DEVELOPMENT REVIEW BOARD
SUPPLEMENTAL SUBMITTAL

PROJECT NO. PR-2020-004820

To: Jolene Wolfley and DRB Members, City of Albuquerque
From: Michael Vos, AICP, Consensus Planning, Inc.
Date: April 15, 2021
Re: Hotel Circle Ramada Apartment Conversion DRB Update (PR-2020-004820)

This memo provides updates on the proposed apartment conversion based on the comments received at the March 31, 2021 DRB meeting. The comments are numbered, and responses are in bold italics.

LANDSCAPE PLAN

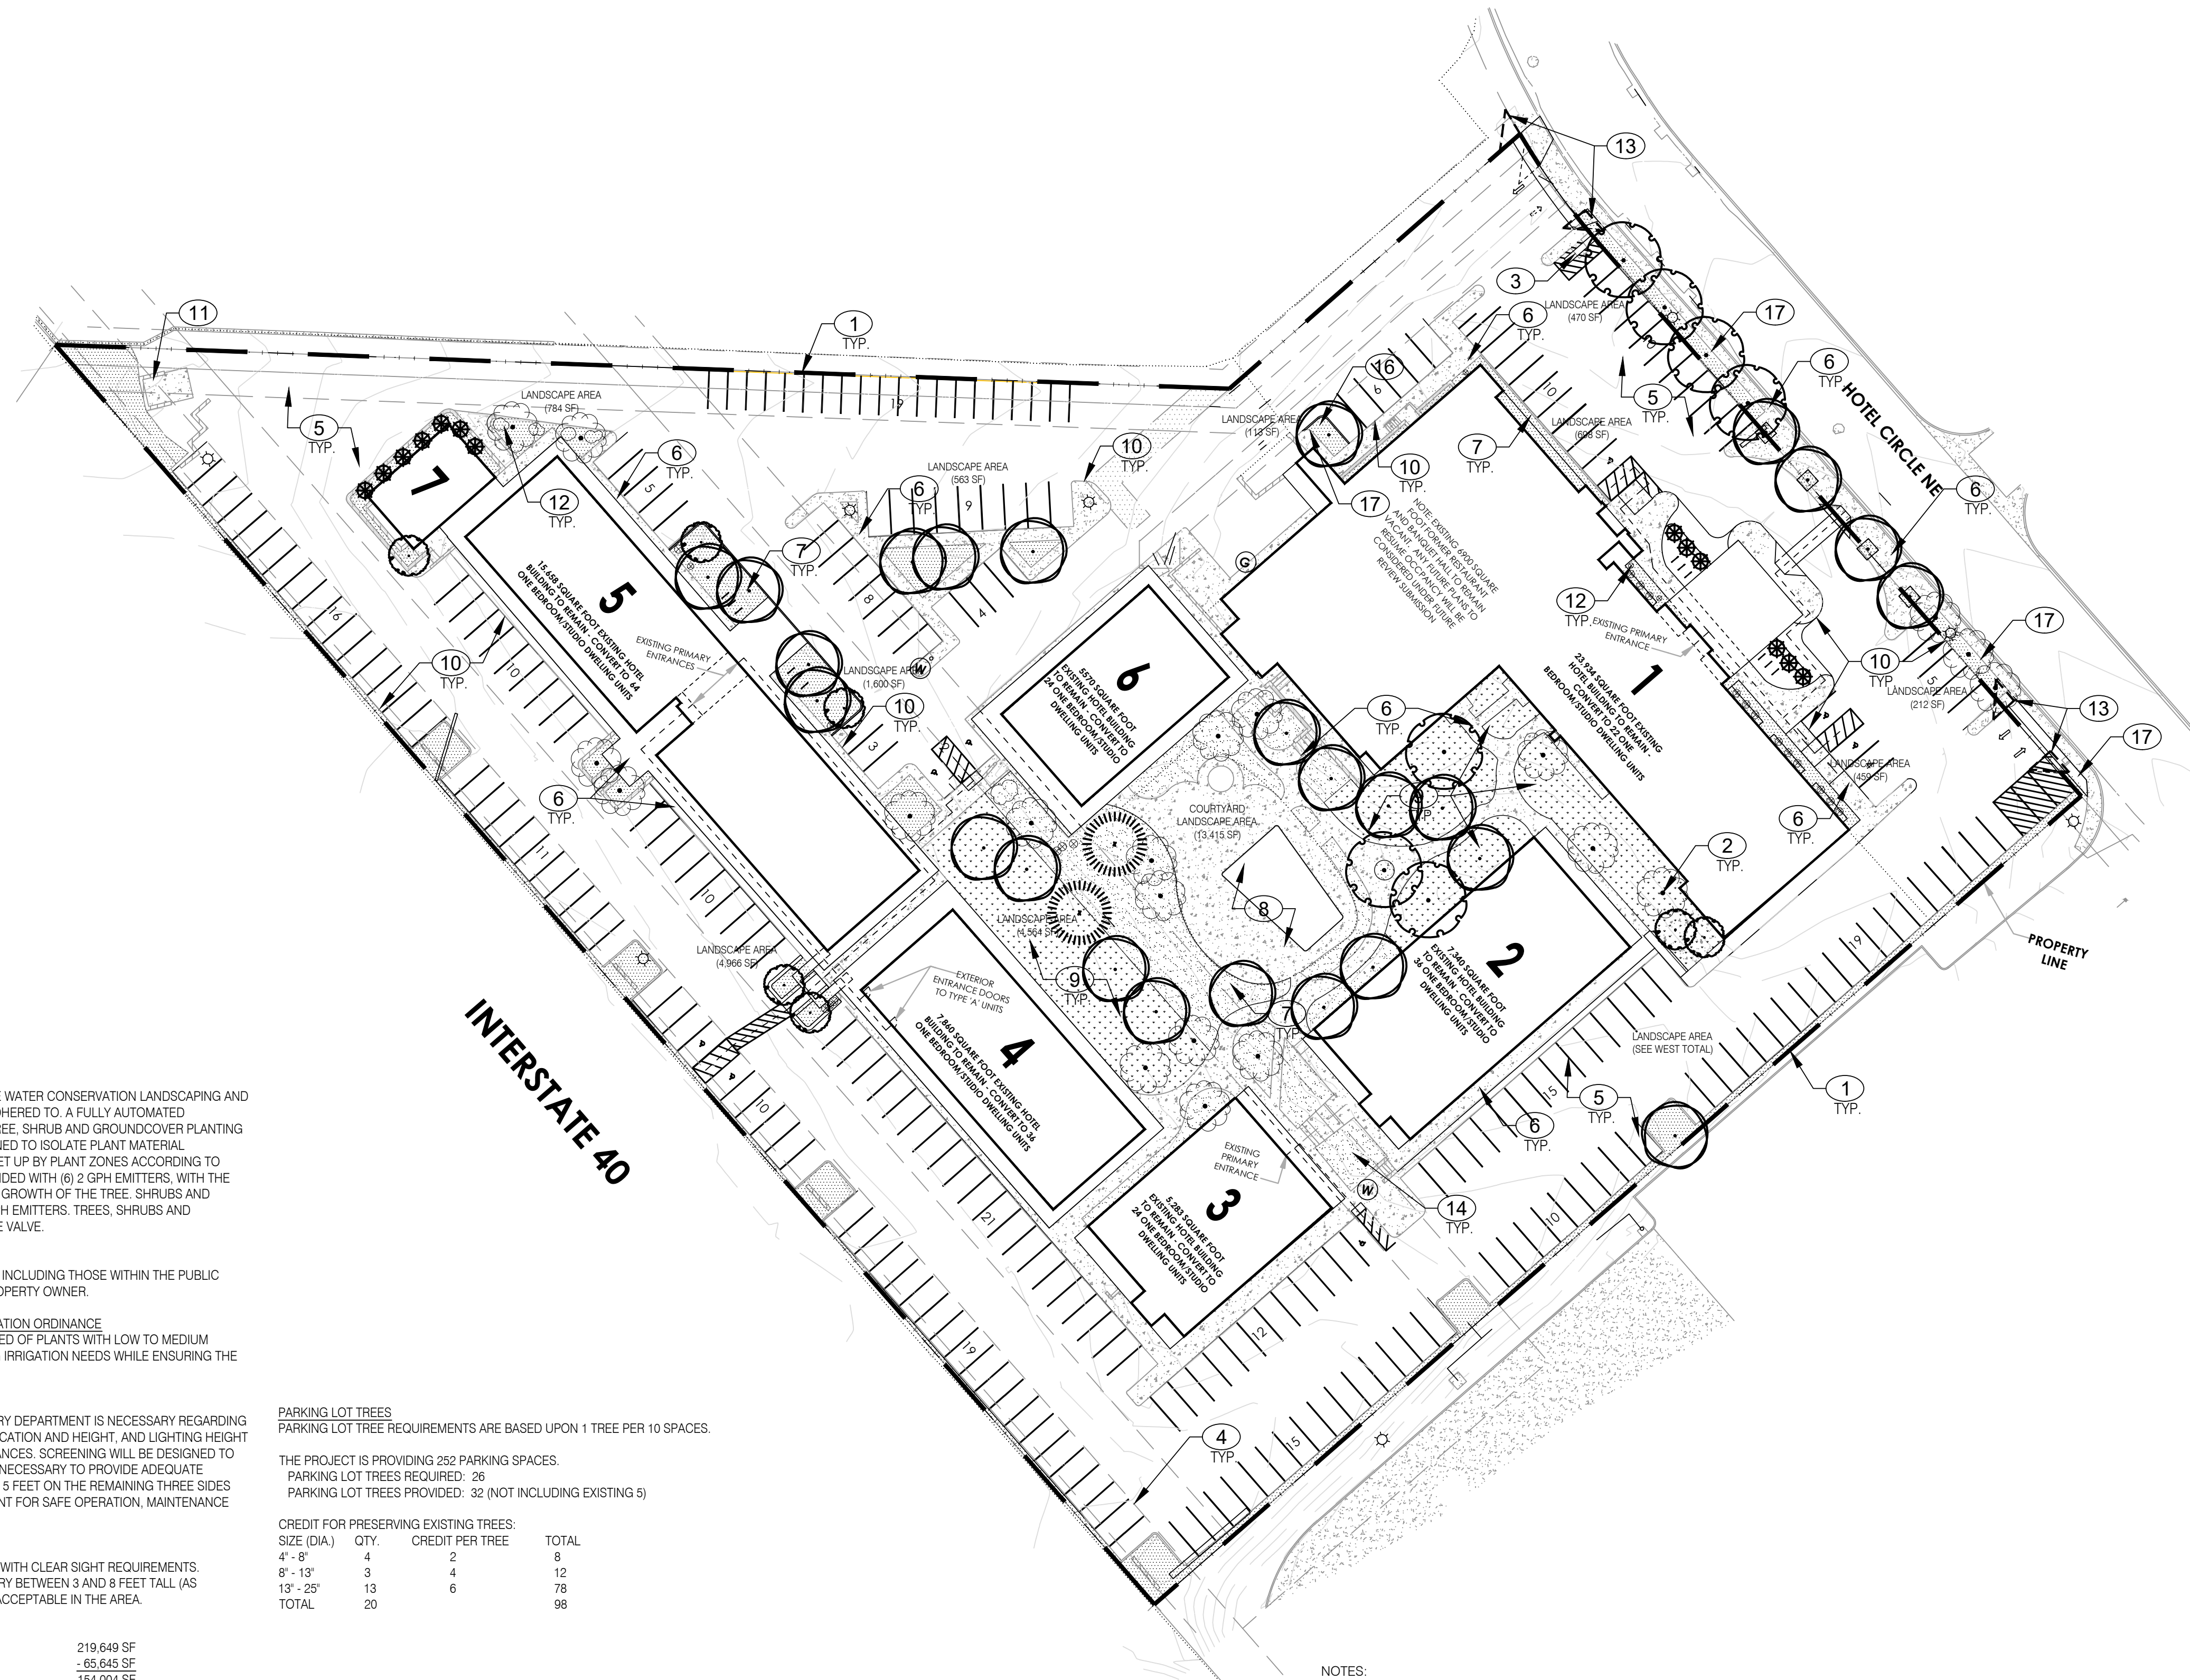
2. The Building #6 and southeast building exhibit on the encroachment and additional easement have been received. This will be reviewed with ABCWUA Legal and Water Operations. An encroachment notice is possibly needed regardless of the additional easement.

- a. ***We received further comment from Blain Carter via email regarding the encroachments and relationship between the easements on site and the proposed landscape plan. We have updated the landscape plan to relocate the trees within the courtyard out of the waterline easement and eliminate the trees that were proposed in the perimeter sewer easement at the south side of the site. The existing fence that is within the courtyard is not shown on the plan as it will be removed by this redevelopment. The only remaining encroachments are two existing trees and the buildings that have previously been discussed. The Applicant requests specific direction from the Water Authority regarding what is required regarding these longstanding site features that encroach in the easement, other than the previously discussed additional easement and notice of encroachment. Attached are additional exhibits prepared by the Civil Engineer, Isaacson & Arfman, regarding the location of the existing waterline and building encroachments.***

SHEET TITLE
SITE UTILITY PLAN
 SHEET NUMBER
CU-101

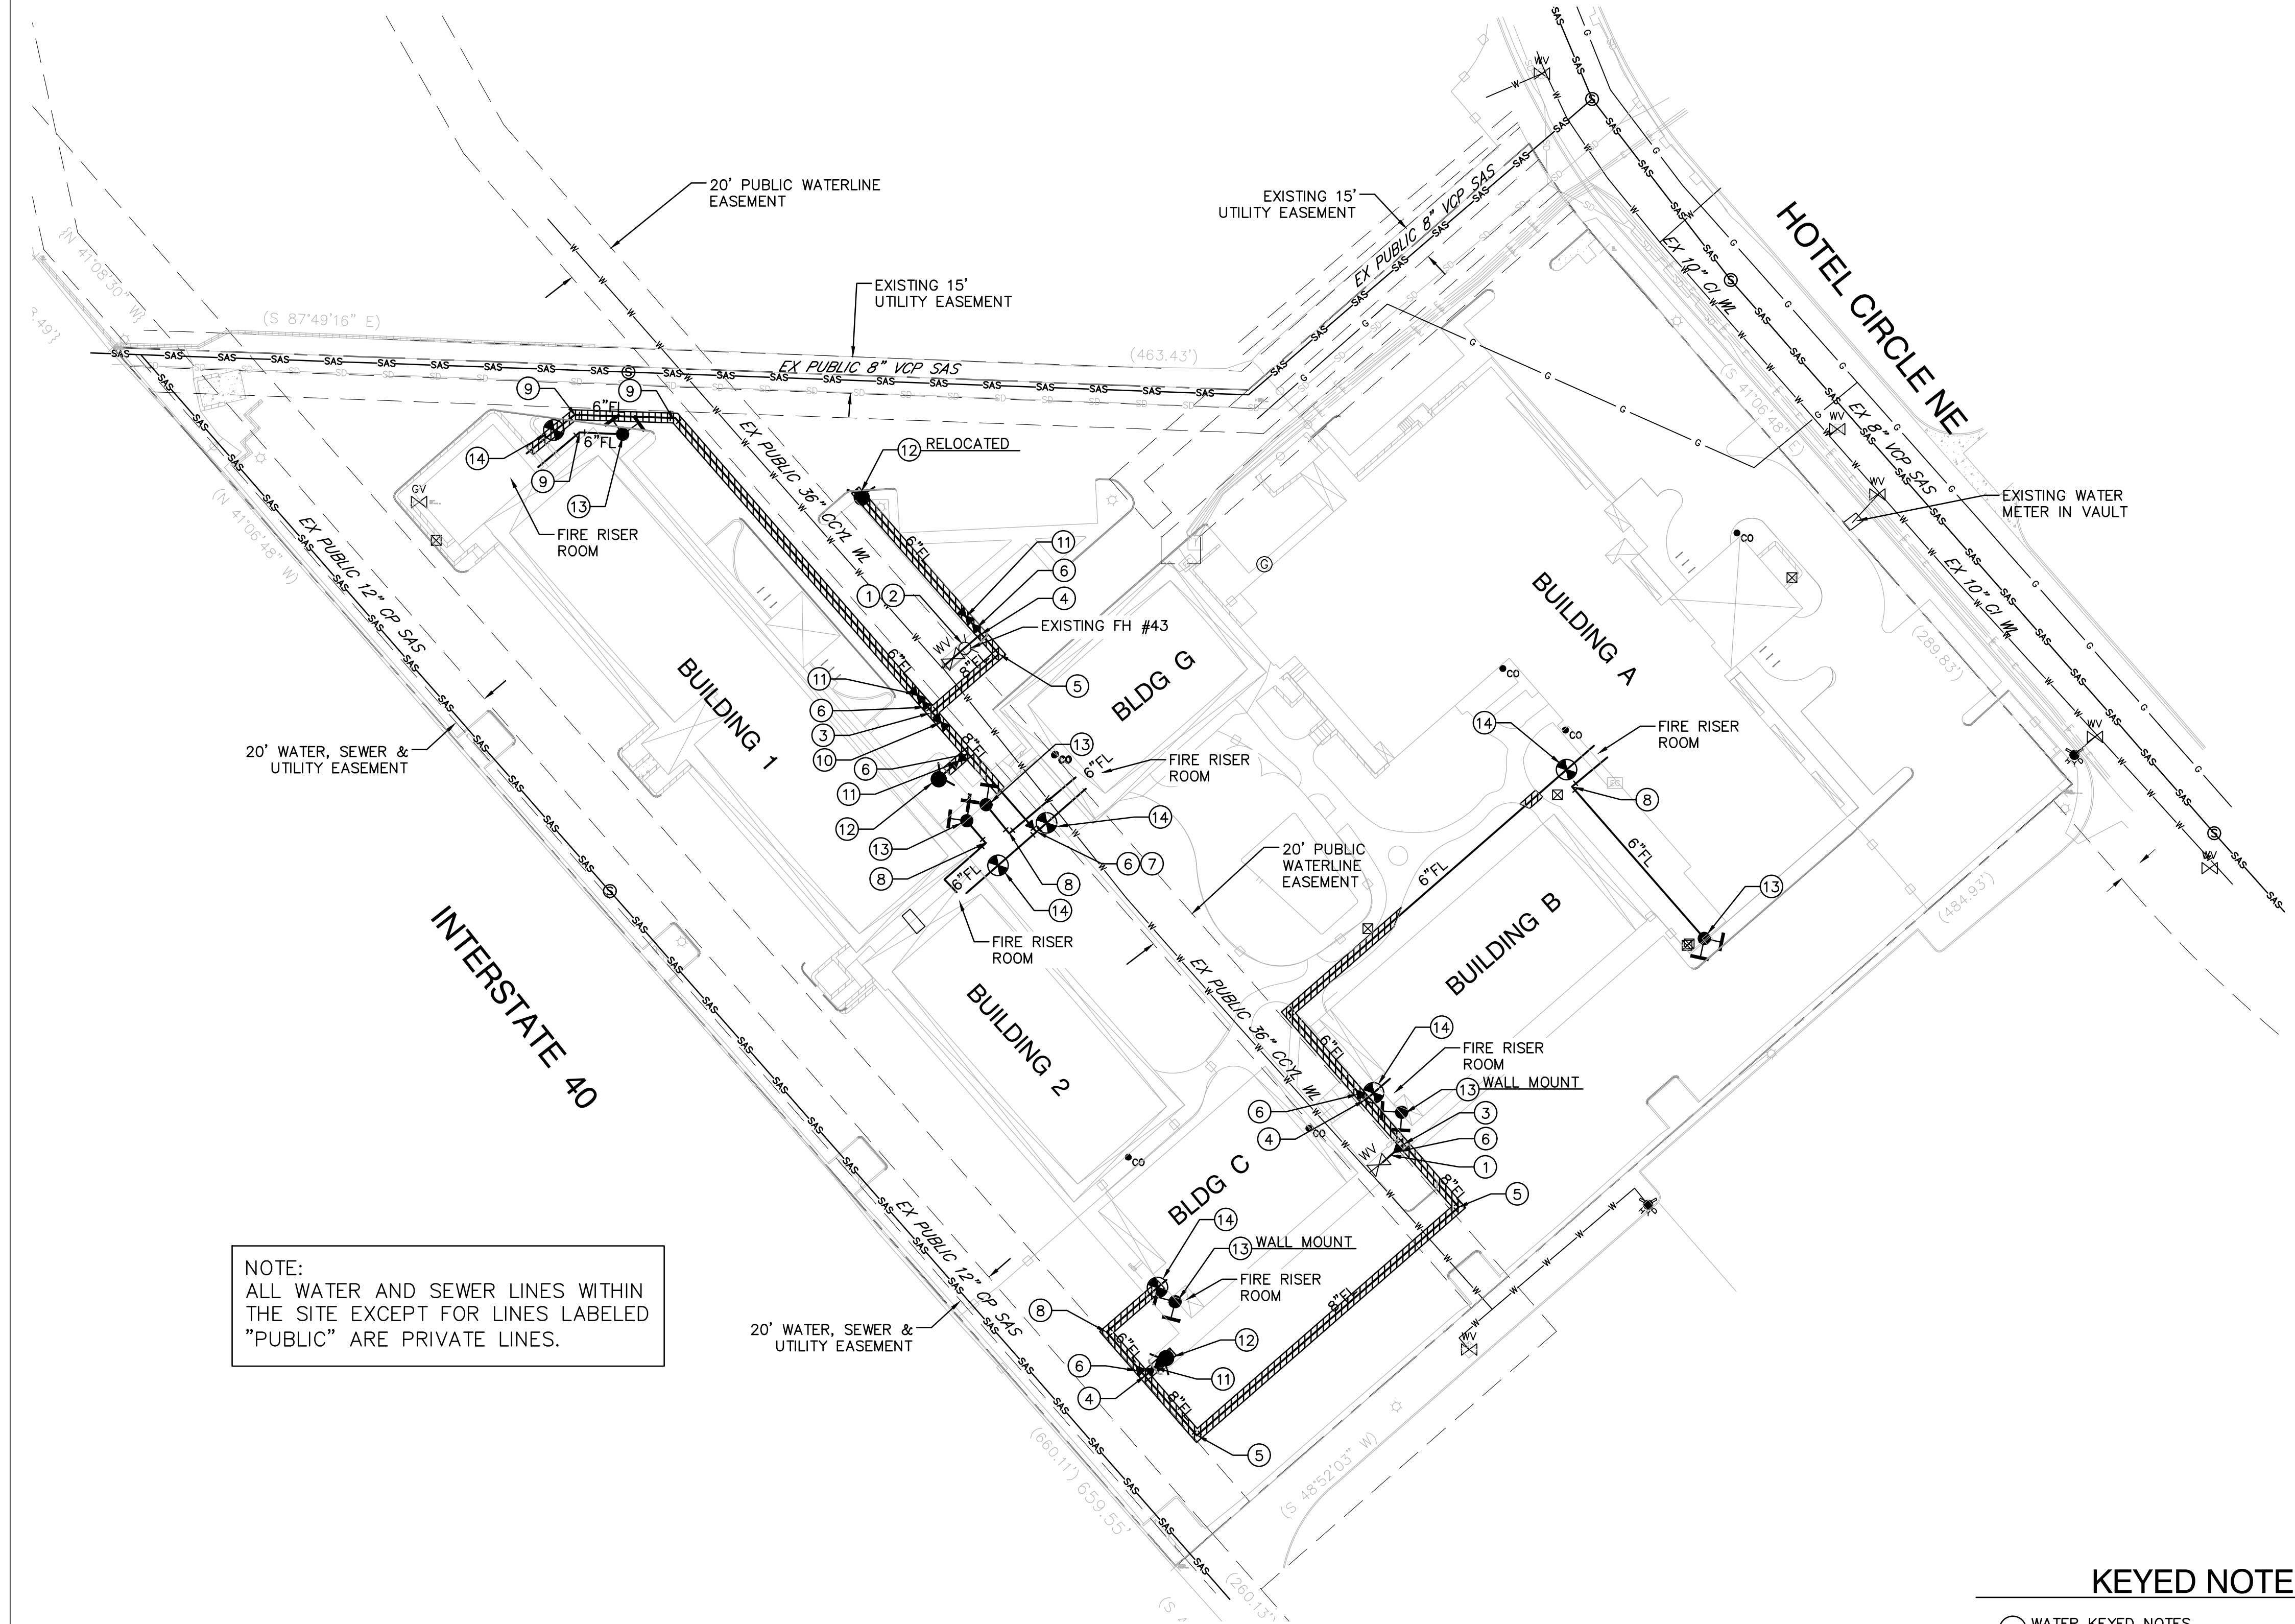
The location of the fire lines has been revised as requested. Thank you.
The private fire lines have been relocated outside of the public waterline easement.
Thank you.

- a. ***Noted.***
4. PREVIOUS COMMENT: For information only.
